UFCA FLORIDA GULF COAST HOSPITAL
Outpatient Rehabilitation & Diagnostic Center
DIAGNOSTICS MRI
ADDITION

HCA Diagnostic Center MRI Addition Bid Addendum No. 1

Date: 04/25/25

DAG Project #: 24107

A: Refer to the new Architectural Site Plan for existing conditions available.

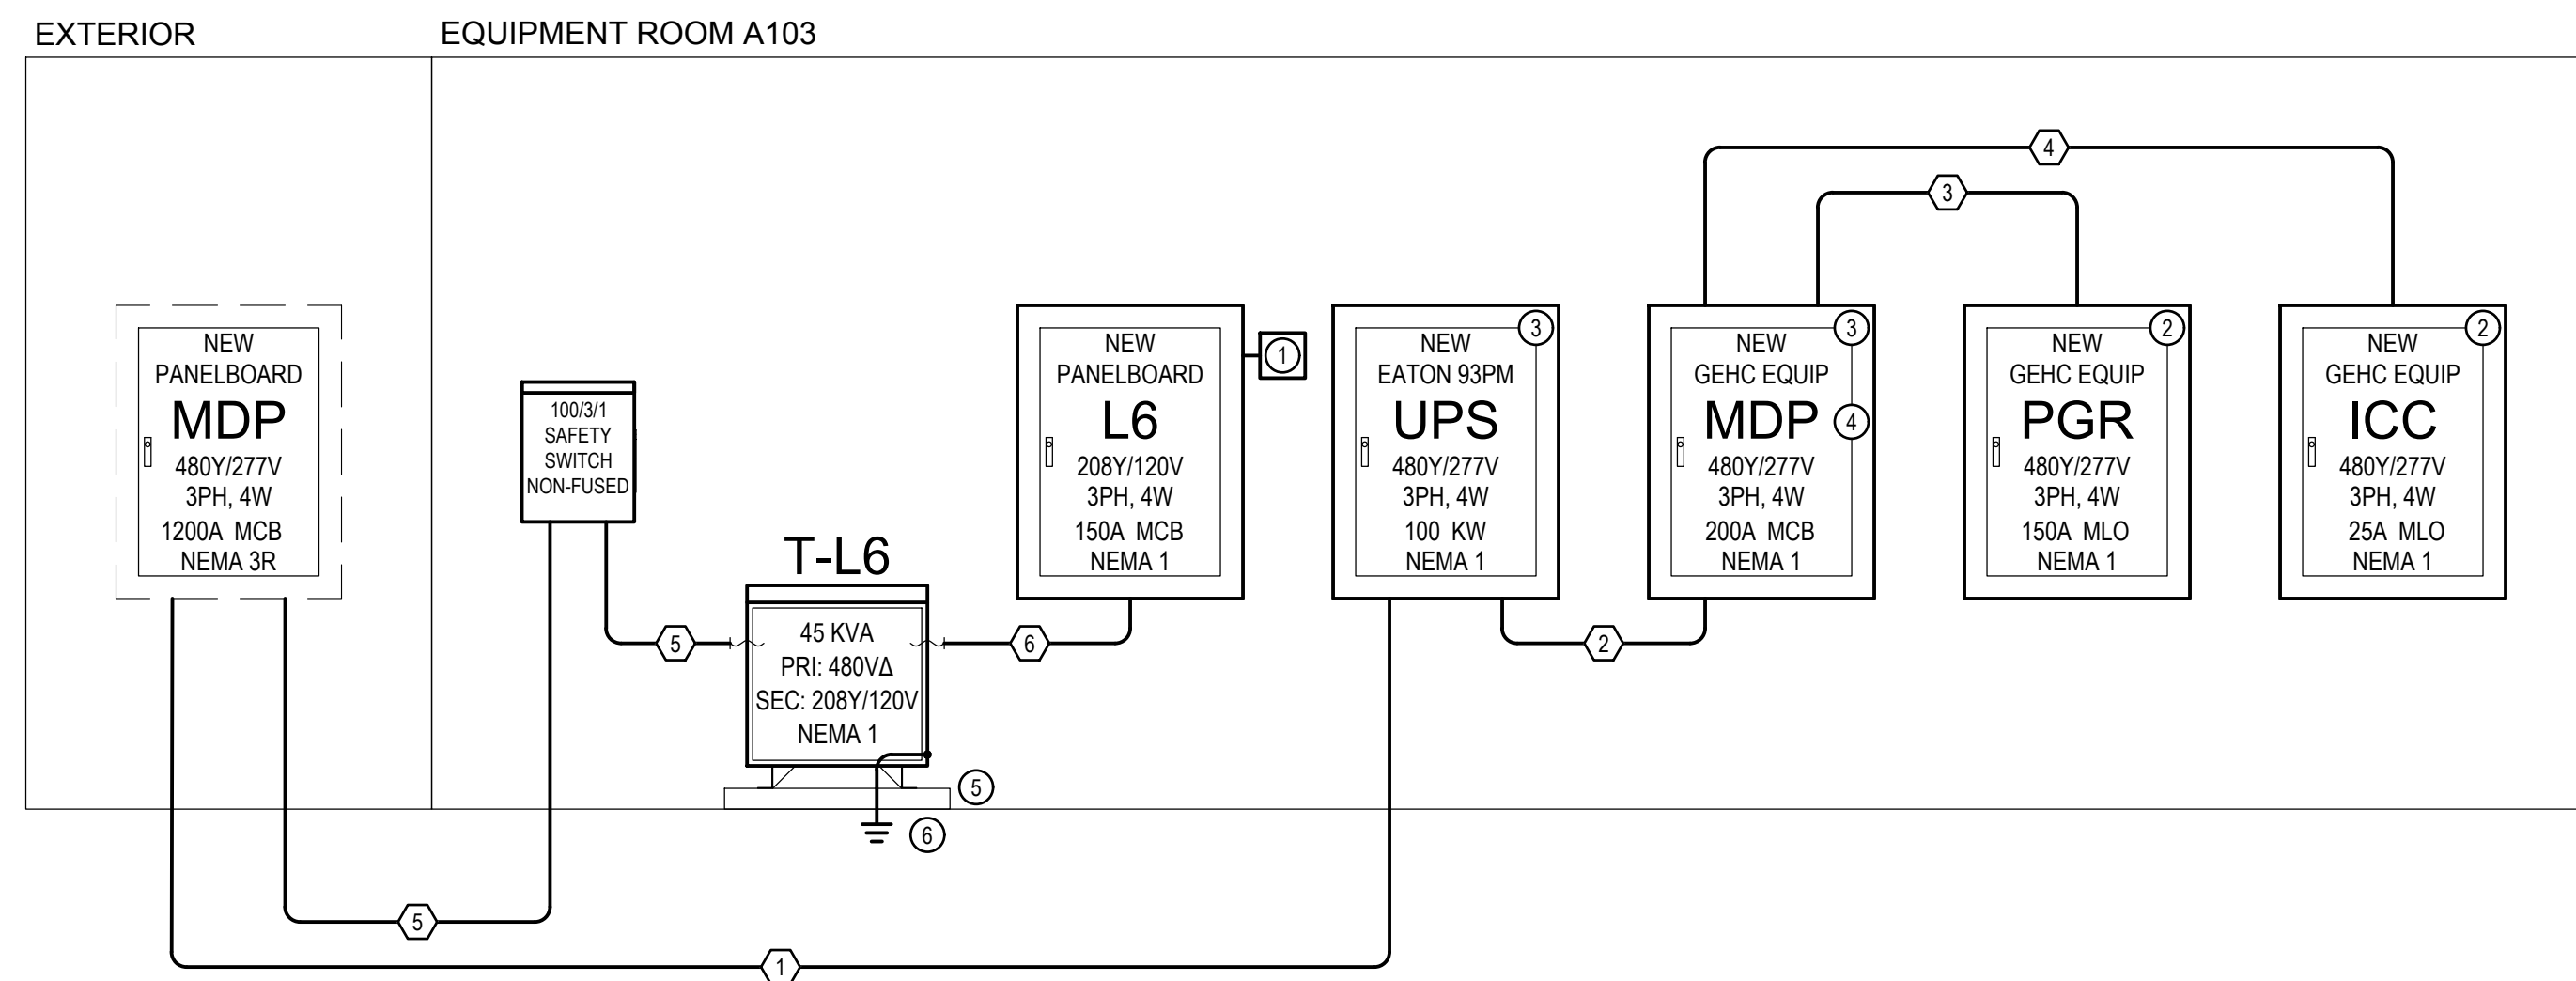
- dd. Updated Sheet numbering from E-701 to better conform to AIA standards.
 - ee. Added Partial Grounding Diagram.
- E-602
 - ff. Updated Sheet numbering from E-801 to better conform to AIA standards.

A: Refer to sheet E-601 for grounding information.
